L-2012-191
10 CFR 50.90

Re: Turkey Point Units 3 and 4
Docket Nos. 50-250 and 50-251
Responses to Requests for Additional Information Related to LAR 210, DC Sources

**Response to Request for Additional Information
Related to LAR 210, DC Sources**

ATTACHMENT 2
Cell Interconnection Resistance And Voltage Readings
 (Page 1 of 2)

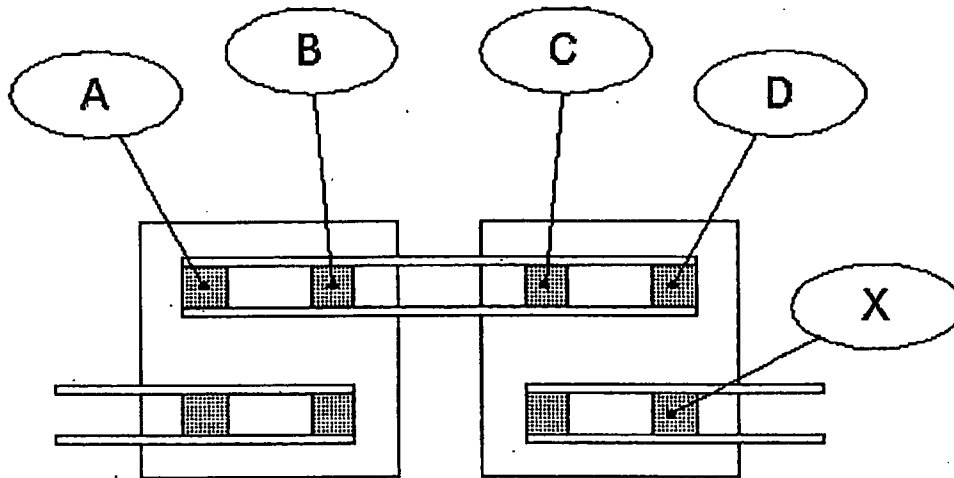
In the LAR, the licensee stated that the requested TS SR revised battery cell connection resistance values are based on past battery surveillances measured resistance values for clean, tight battery cell connections plus a small margin (5 to 7 micro-ohms, approximately 20%). Provide the results of at least two past battery surveillances showing the measured resistance values.

Attachment 3 of Procedure 0-SME-003.04 provides the as found measured resistance values for recent surveillances of safety related Batteries 4B, 3B, 4A and 3A. Attachment 2 of Procedure 0-SME-003.04 identifies the acceptance criteria and is also provided. All measured resistance values are within the acceptance criteria. (See Attachment 1 of this Enclosure)

**Gould Battery Graph - Percent Capacity verses Years
(1 page)**

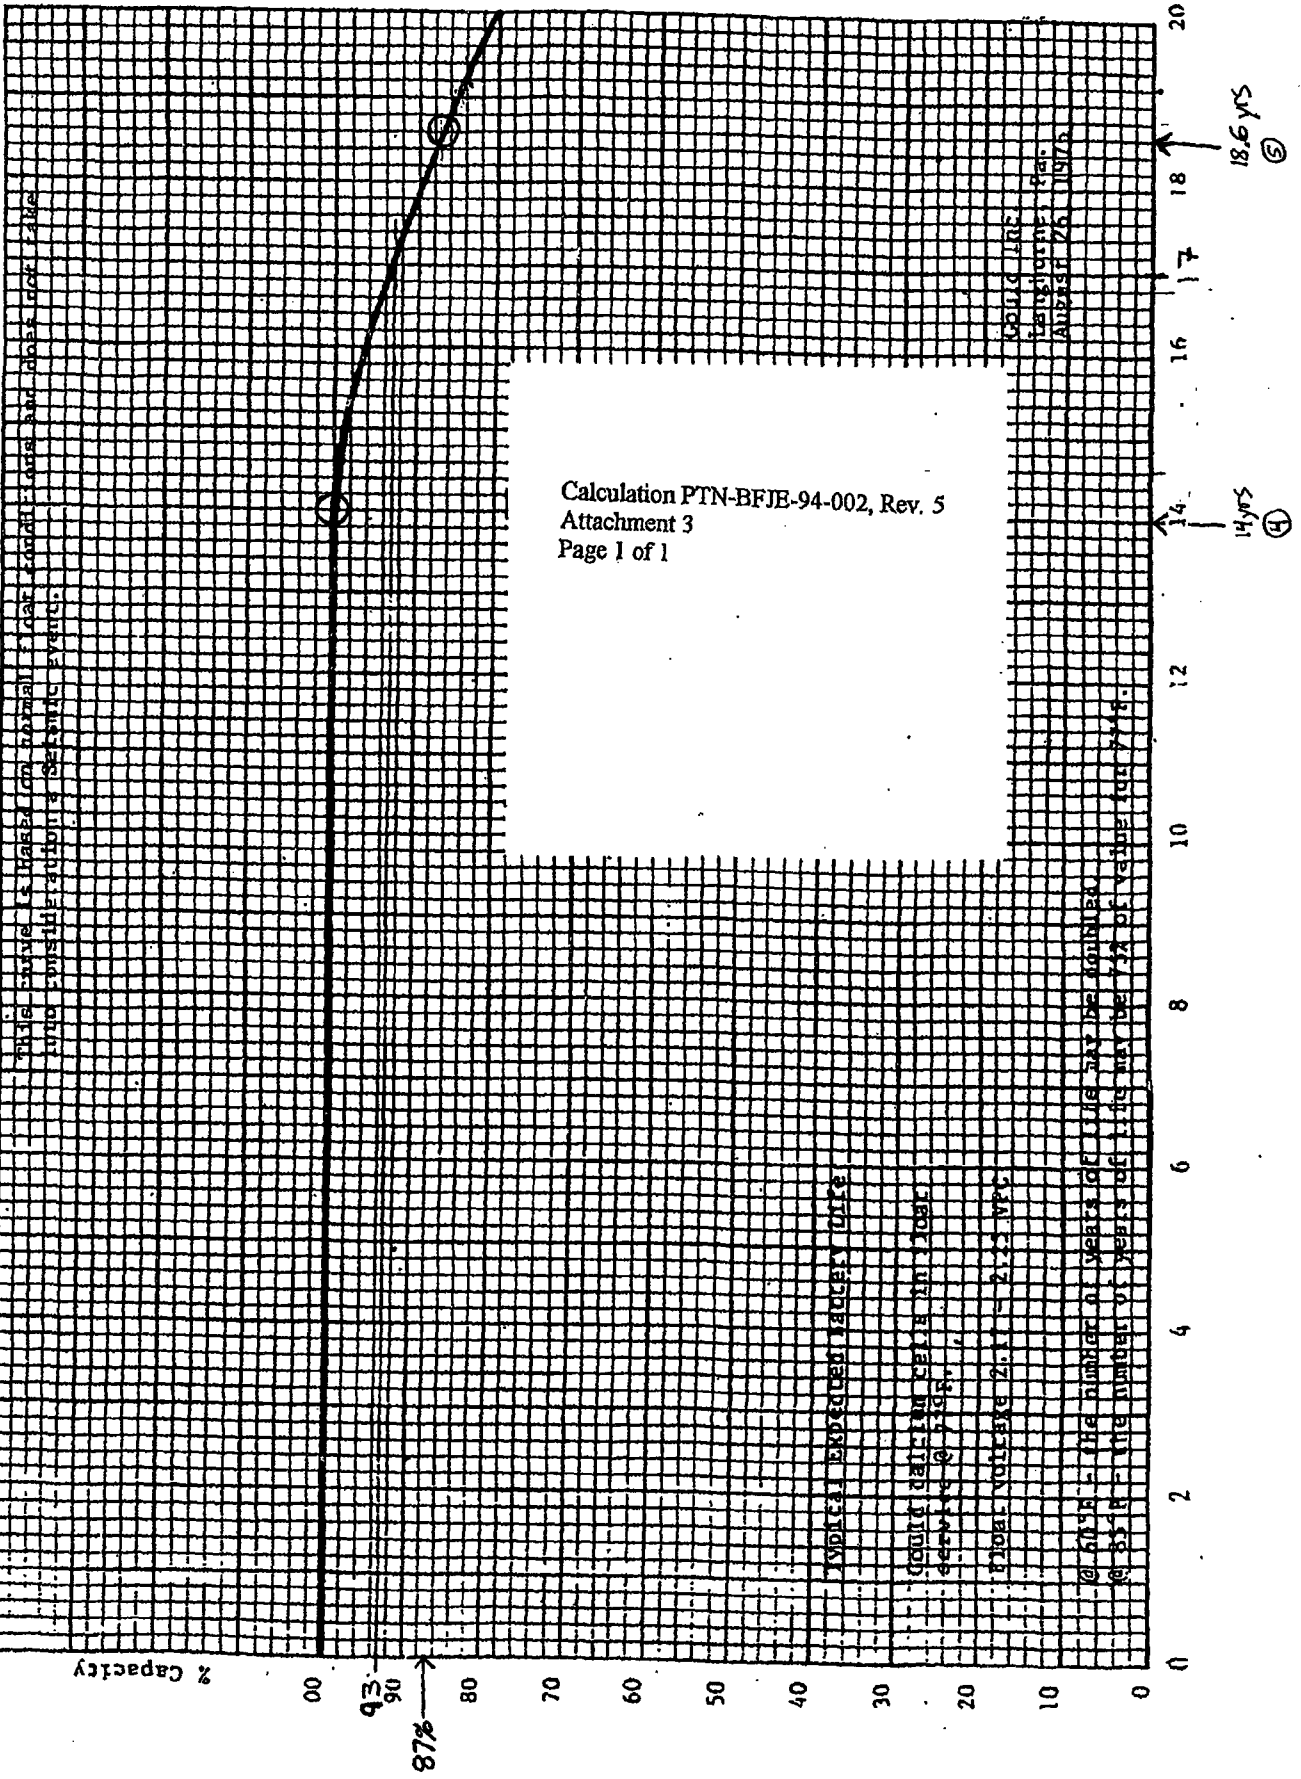
In the LAR, the licensee stated that the vendor's typical expected battery life curve indicates a 100% battery capacity over the initial 14 years.

Provide the basis and any supporting documents to confirm the above statement.

The "Typical Expected Battery Life" curve provided by Gould Inc. in 1975 (Attachment 3 to calculation PTN-BFJE-94-002 Rev.5 (See Attachment 2 of this Enclosure)) shows a battery capacity of 100% up to 14 years. From the 14 year mark the capacity of the batteries drop off steadily to approximately 80% capacity at the 20 year mark. Therefore, if a battery is expected to operate for a 20 year time period, then the battery would be designed with an Aging Factor of 1.25 ($1 / 1.25 = .80$) which would ensure that the battery would still cover 100% of the load after 20 years.

With an Aging Factor of 1.15 ($1 / 1.15 = .867$) the battery would degrade to 100% of the load after 18.6 years. This can also be seen on the "Typical Expected Battery Life" graph. With 100% of the designed load being at 86.7% of the battery capacity, the battery will only be able to supply the full load for 18.6 years. After this time period the capacity of the battery would no longer be capable of providing 100% of the load. (See Attachment 2 of this Enclosure)
